Access Compliance Report

Public Rights-of-Way

(Curb Ramps)

Intersection ID: 53416	Main Street: WAVERLY_CENTER_DR	Cross Street: SOUTHGROVE_ST	Location: SE
ADA ID: 33629F133103	Ramp Type: Perp	Initial Pass/Fail: Fail	Overall Compliance: No
Severity Score: 8.75			
Codes/Mitigation Info/Possible Solution		Field Measurements/Component Compliance

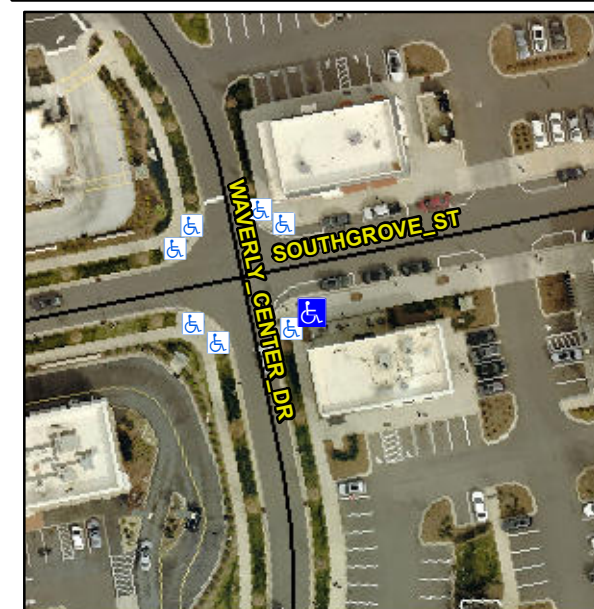
Not Found, R304.5.1

Compliance	Description	Data	Compliance	Description	Data
N/A	Ramp Length (in)	58.0	Yes	Ramp Slope (%)	5.3
No	Ramp Width (in)	45.0	Yes	Ramp XSlope (%)	0.7
N/A	Flare Type LT	N/A	N/A	Flare Type RT	N/A
N/A	Flare Slope LT (%)	N/A	N/A	Flare Slope RT (%)	N/A
N/A	Flare Traversable LT?	N/A	N/A	Flare Traversable RT?	N/A
N/A	Landing Length (in)	N/A	N/A	DWS Provided?	N/A
N/A	Landing Width (in)	N/A	N/A	DWS Contrast?	N/A
N/A	Landing Slope (%)	N/A	N/A	DWS Length (in)	N/A
N/A	Landing X Slope (%)	N/A	N/A	DWS Full Width?	N/A
N/A	Landing Curb? (Y/N)	N/A	N/A	DWS Offset (in)	N/A
N/A	Shared Landing?	N/A			
N/A	Gutter Ponding?	N/A	N/A	Gutter Slope (%)	N/A
N/A	Gutter Lip Ht (in)	N/A	N/A	Gutter X Slope (%)	N/A
N/A	Painted X Walk1?	No	N/A	Painted X Walk2?	N/A
	X Walk 1 Direction	To N		X Walk 2 Direction	N/A
N/A	X Walk 1 Width (in)	N/A	N/A	X Walk 2 Width (in)	N/A
	X Walk 1 Slope (%)	2.9		X Walk 2 Slope (%)	N/A
	X Walk 1 X Slope (%)	1.8		X Walk 2 X Slope (%)	N/A

Remove & Replace Entire Ramp.
